DEVELOPMENT REVIEW BOARD
SUPPLEMENTAL SUBMITTAL

PROJECT NO. PR-2019-002277
Application No. SI-2019-00246

SUBMITTAL DESCRIPTION: DRB Site Plan Resubmittal.

**RE: Adagio Apartments
PR-2019-002277**

SHEET NUMBER: C-100

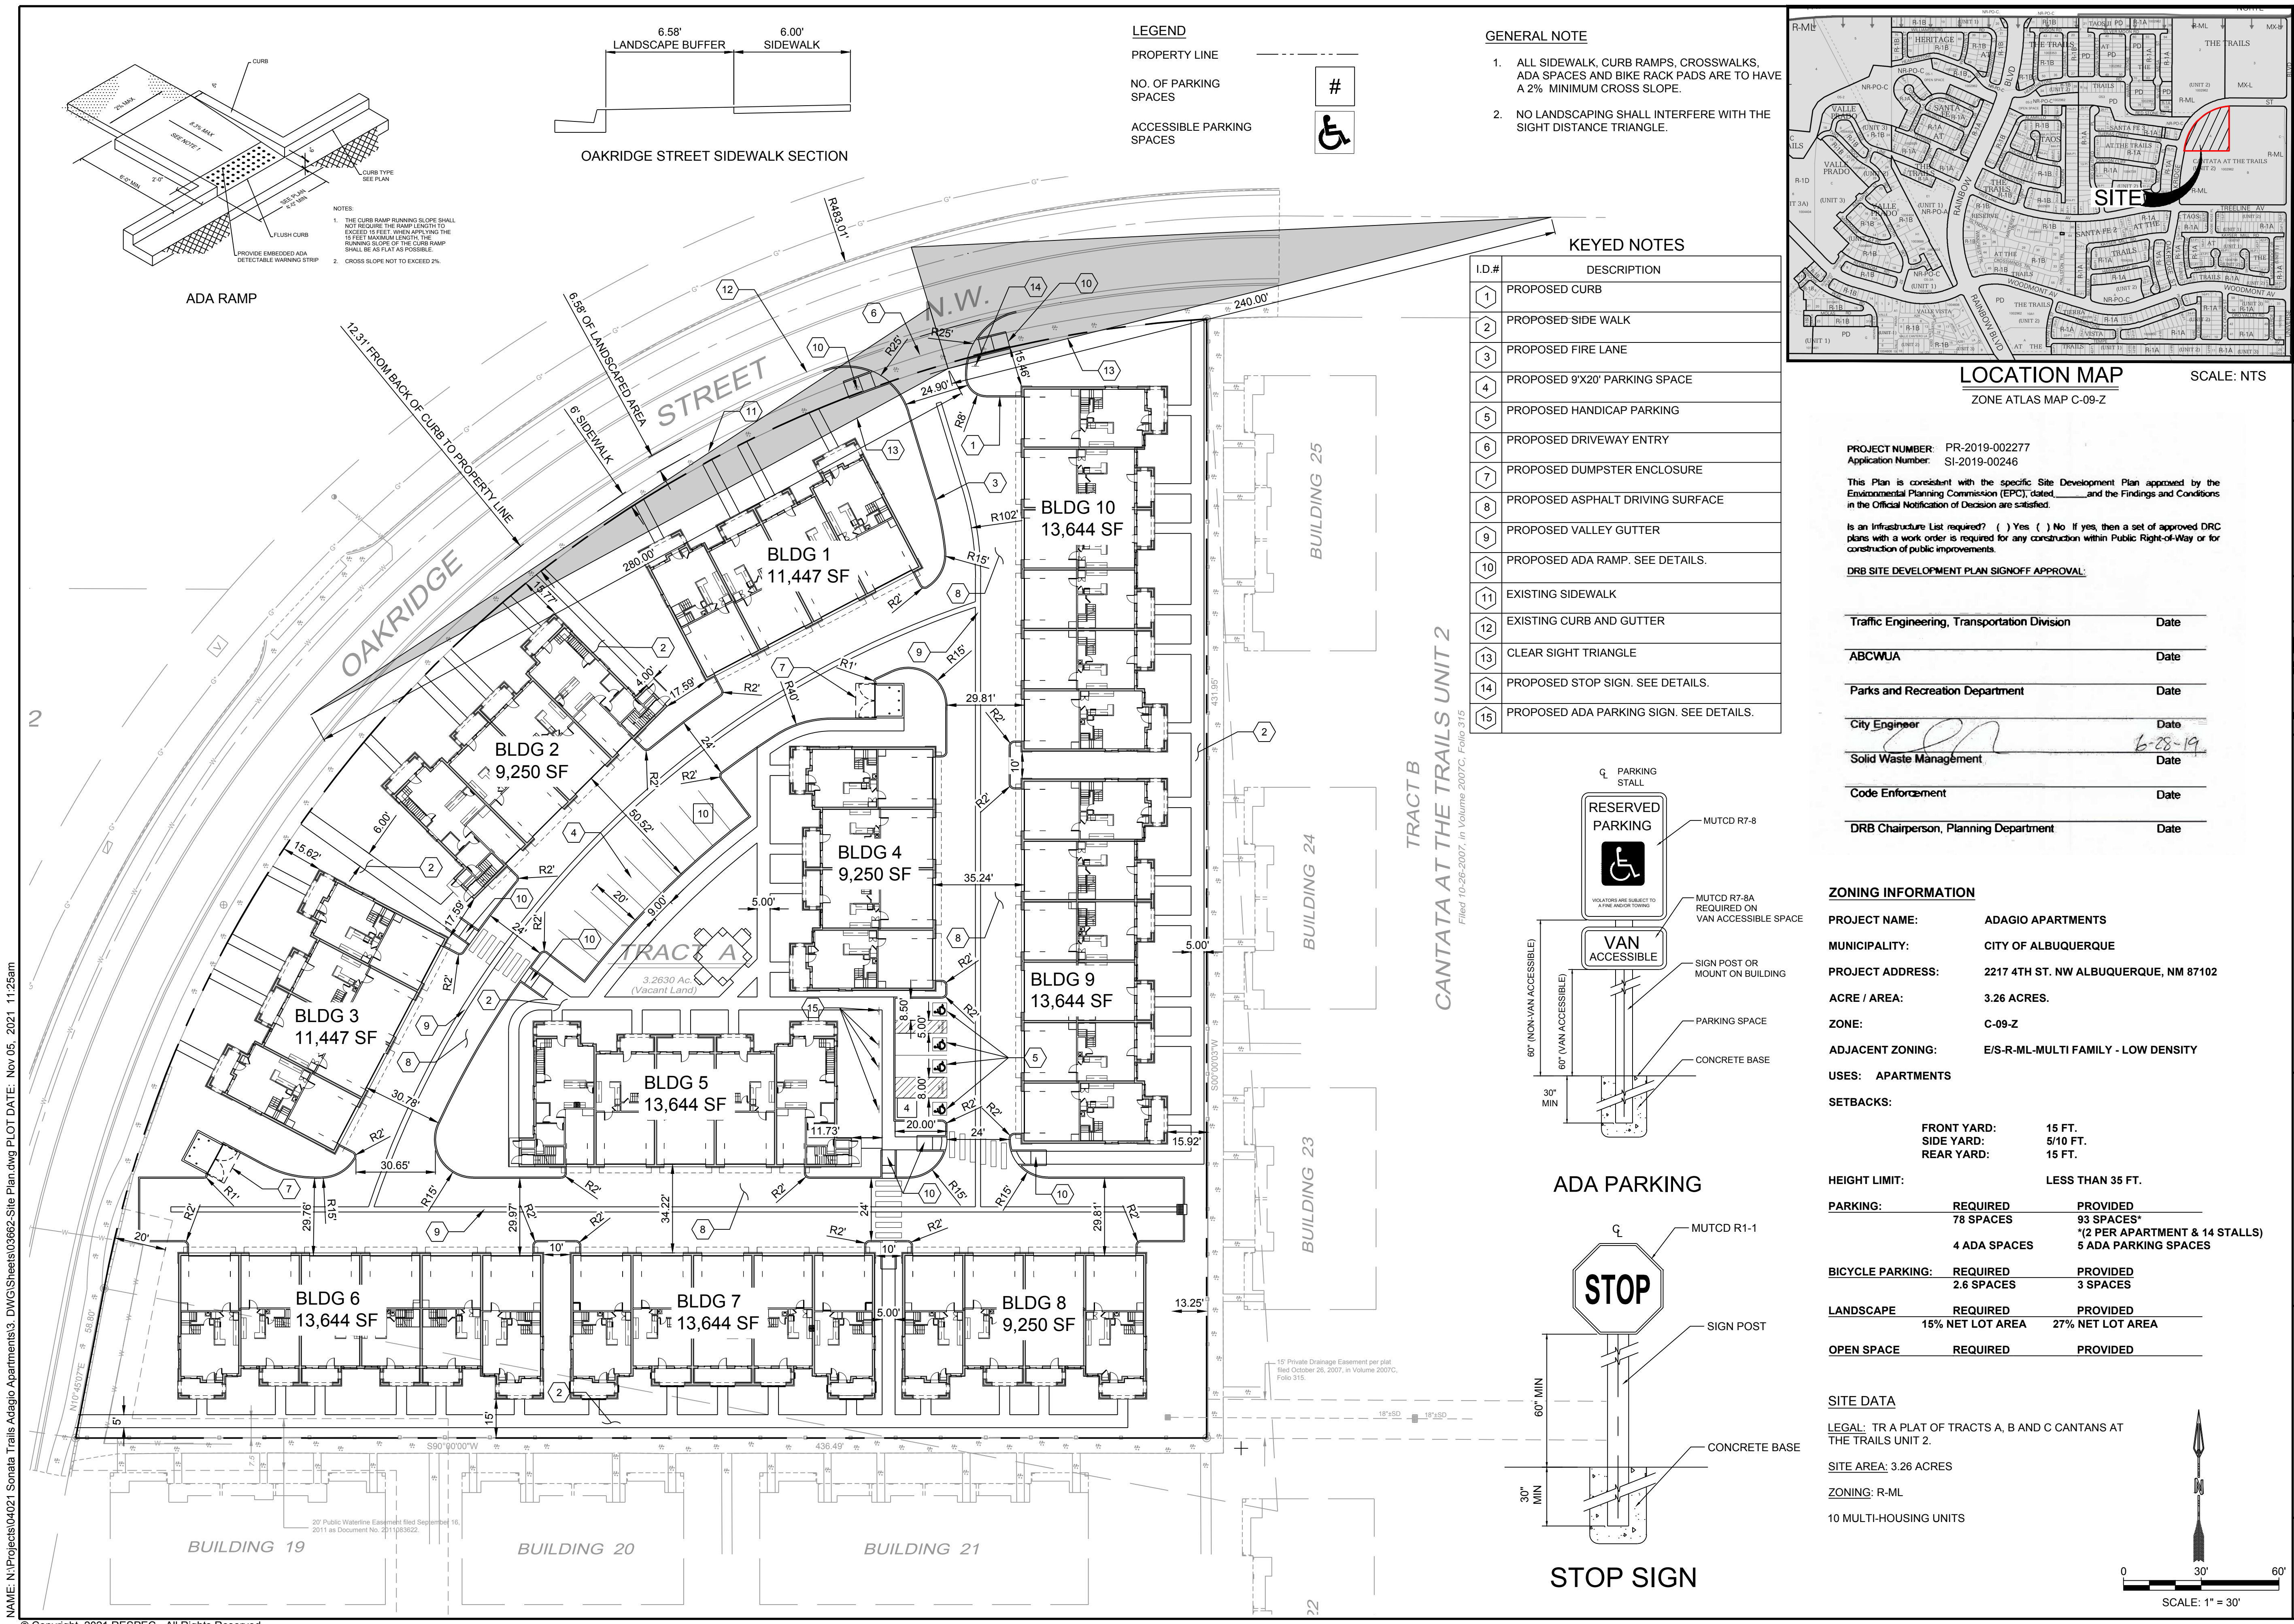
- / Provide a sidewalk exhibit for Oakridge Street showing the width of sidewalk and landscape buffer as well as the distance from back of curb to the property line.

- o *Response: See general note 1 on the revised site plan attached.*
- / Use keyed notes and graphics on the site plan to show curb ramp locations and bicycle parking space calculations.

- / Due to the curve for Oakridge Street, provide sight distance lines according to AASHTO Standards on both the site plan and landscaping plan and include the standard note for landscaping height restrictions. Make sure that no proposed landscaping interferes with sight distance.

- / It is not apparent what type of pavement surface is being proposed. A hard driving surface will be required as part of this proposed project for parking area and drive aisles.

- / The ADA accessible parking sign must have the required language per 66-7-352.4C NMSA 1978 "**Violators Are Subject to a Fine and/or Towing.**" This wording should be more visible on the plan. (Please call out detail and location of signs on the plans.)

- o *Response: A detail has been provided on the attached site plan.*
- / List number of multi-housing units on plan. With the parking calculations, include bicycle parking and handicapped space calculations.

- o *Response: See revised site plan attached including keyed notes to show curb ramps. A bicycle parking location still needs to be determined and will be showed and called out in a subsequent submittal.*

- o *Response: Sight triangles are provided at the entrance. The existing radius of Oak Ridge is approximately 510'. This is the minimum radius for a roadway having a speed limit of 35 mph. Sight distance and stopping sight distances are taken into account for these minimum radii requirements. I believe there is sufficient sight distance provided.*

- o *Response: Asphalt pavement is being proposed. See keyed note 8 on the attached site plan.*
- / Has the Fire Marshall approved the plan? It is advisable to have a second emergency access. (It appears that second entrance could be accessed off of Oakridge with a new ADA-accessible drivepad.

- o *Response: This detail is provided on the attached site plan.*
- / The ADA access aisles shall have the words "**NO PARKING**" in capital letters, each of which shall be at least one foot high and at least two inches wide, placed at the rear of the parking space so as to be close to where an adjacent vehicle's rear tire would be placed. (66-1-4.1.B NMSA 1978). This should be clearly called out on a note or a detail.

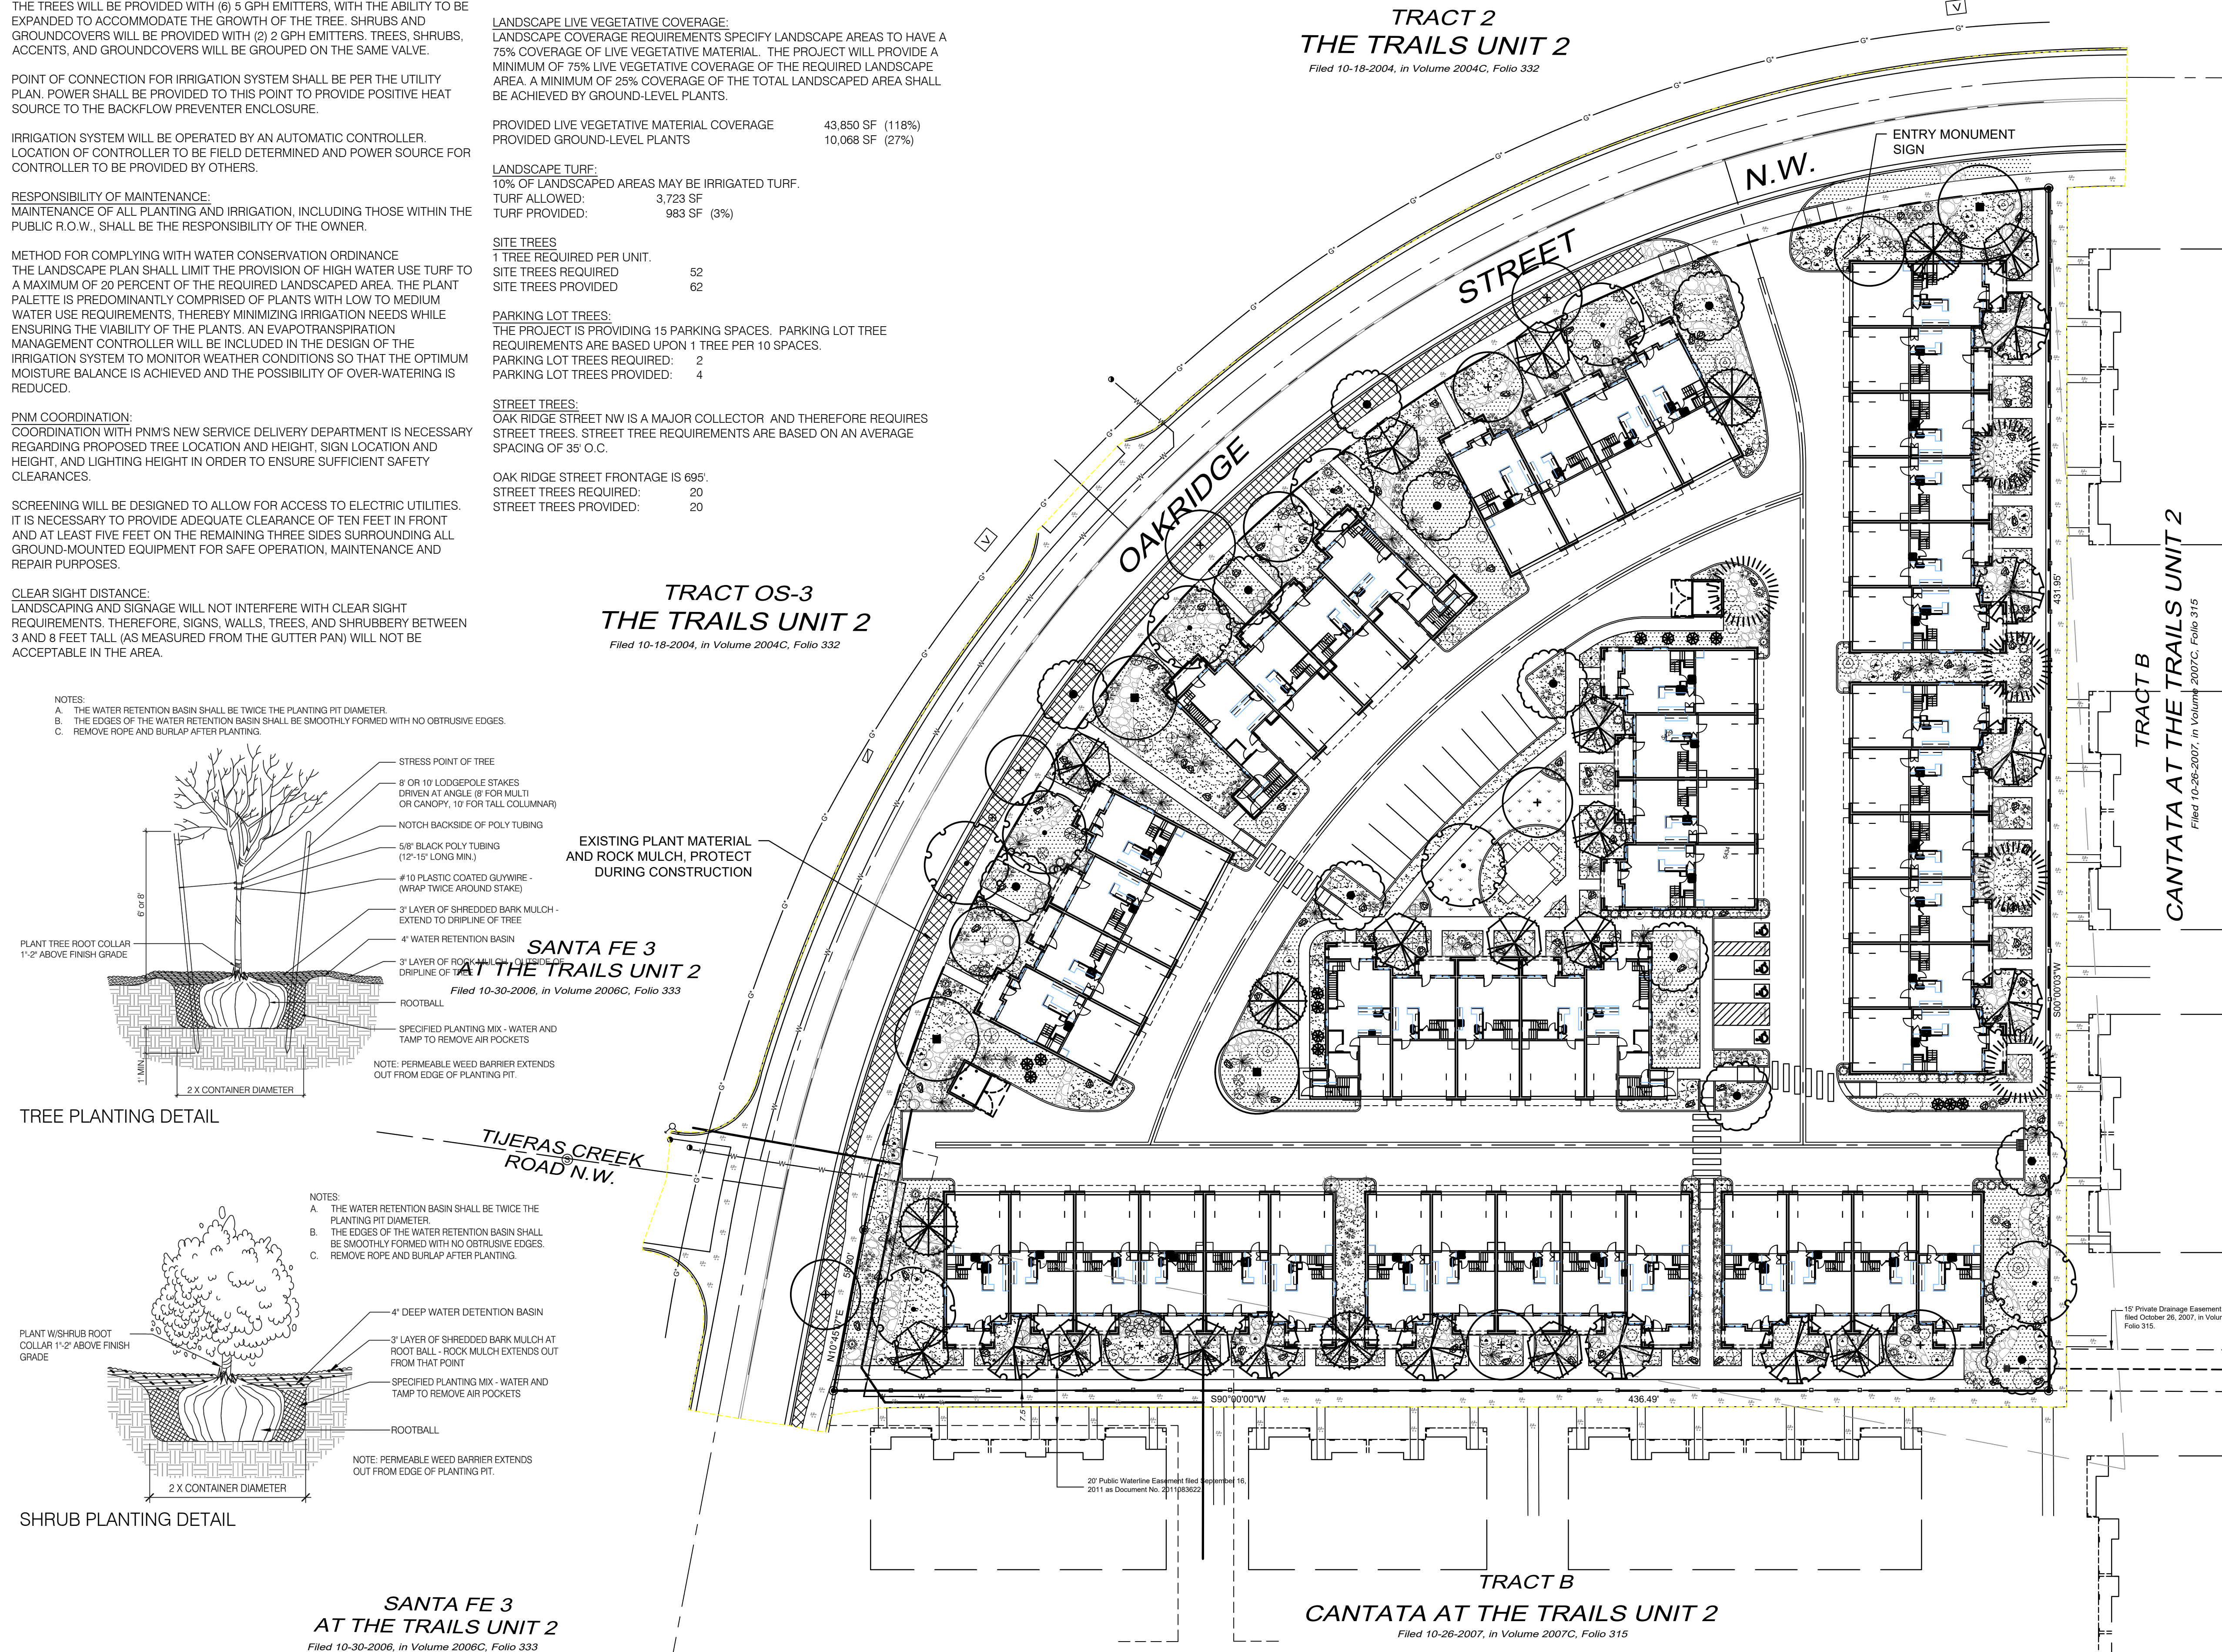
- / Landscape Plan
 - o There is proposed landscaping along the existing waterline near the southwest corner of the subject development. Please confirm trees will not be installed along the existing waterline easement.
 - *Response: Trees will not be installed within the existing waterline easement. See landscape plan attached.*
- / For information only.
 - o The development agreement was approved by the Water Authority Board and has been executed.
 - *Response: Acknowledged.*
 - o Revisions to the development agreement require board approval.
 - *Response: Acknowledged.*
